ADDENDUM NO. 05

13 August 2010

Project: **NEW TRANSPORTATION, MAINTENANCE and AGRICULTURAL BUILDINGS**
Channelview Independent School District

Bay Project No.: **0937**

ADD-05-01
0937
Not To Scale
08/13/2010
A2.01

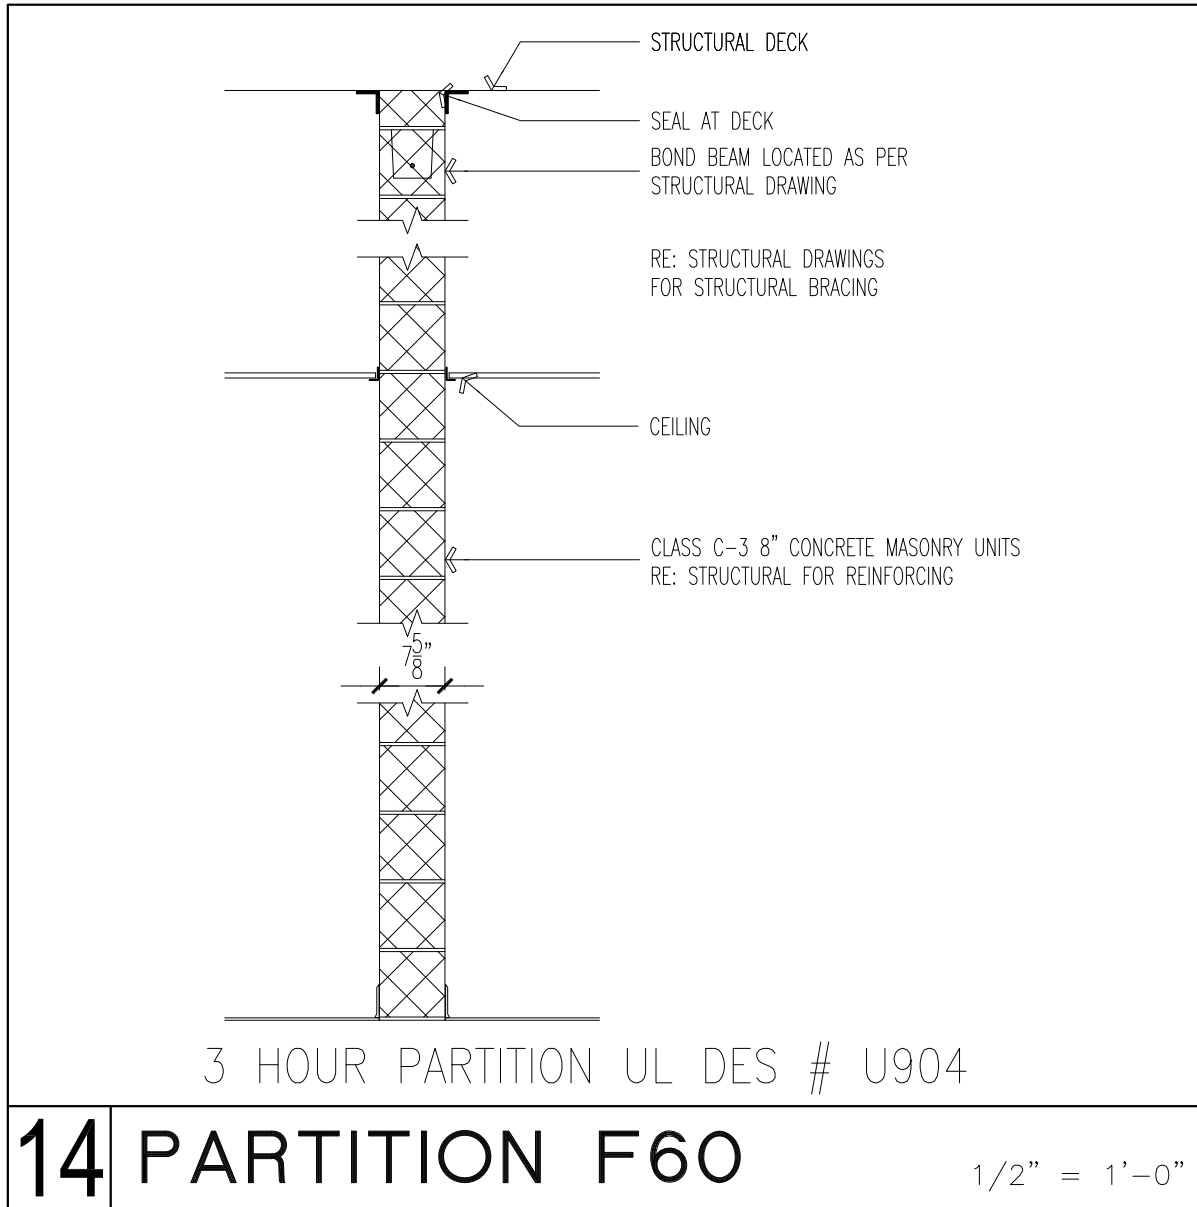
- 18. Sheet A2.03 Maintenance Area "B" Floor Plan: 4/A2.03, Office 310B, delete window 310B-B.
- 19. Sheet A2.03 Maintenance Area "B" Floor Plan: 4/A2.03, Warehouse 405, revise West Wall CMU Partition F54 to F60, 3HR Rated Assembly.
